# Video Products Technical Bulletin 30-2006-071

SUBJECT: REUSE PARTS WHEN REPLACING BK BOARD

MODEL: BVM-1310

Figure 1

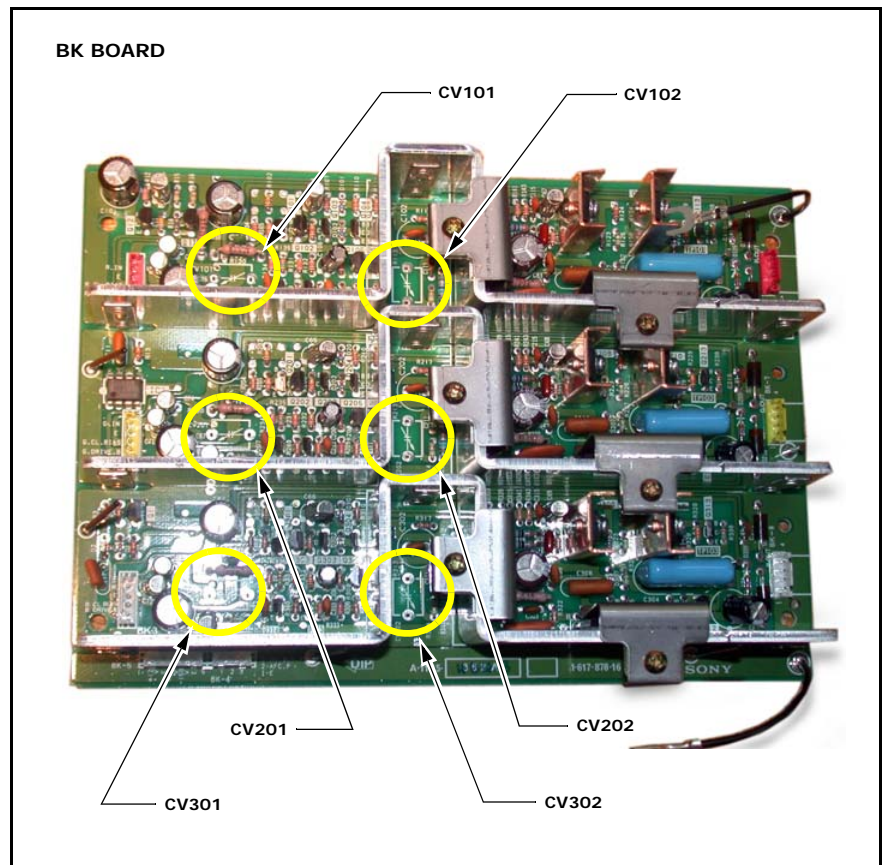
When you replace the BK board (A-1135-362-B), remove the following parts from the former board and install them on the new board.

The new BK board does not contain the parts, and the parts are no longer available. (See Figure 1.)
